A117.1 2003 errata

28 August, 2008

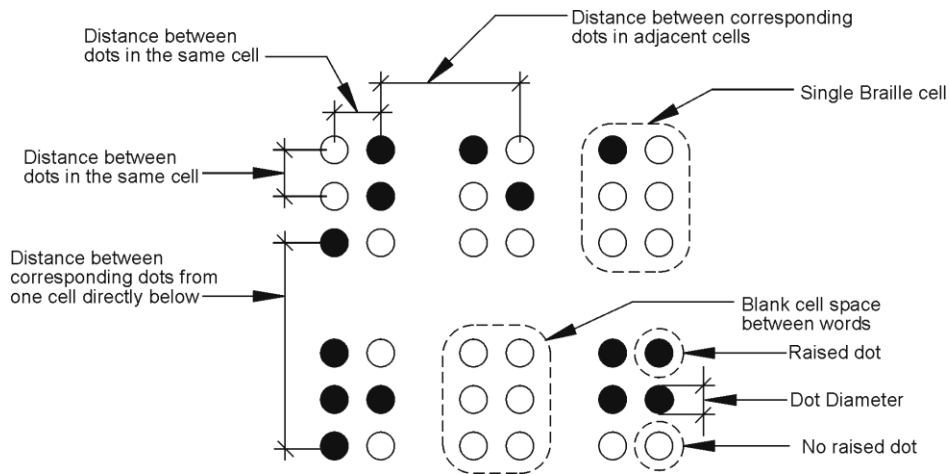
- Page 68: In Figure 703.4.3 the dimension string on the left side for the “Distance between corresponding dots from one cell directly below” and the string along the top for “Distance between dots in adjacent cells” should be modified to measure to the corresponding dots in the adjacent cells. Figure should appear as shown below.
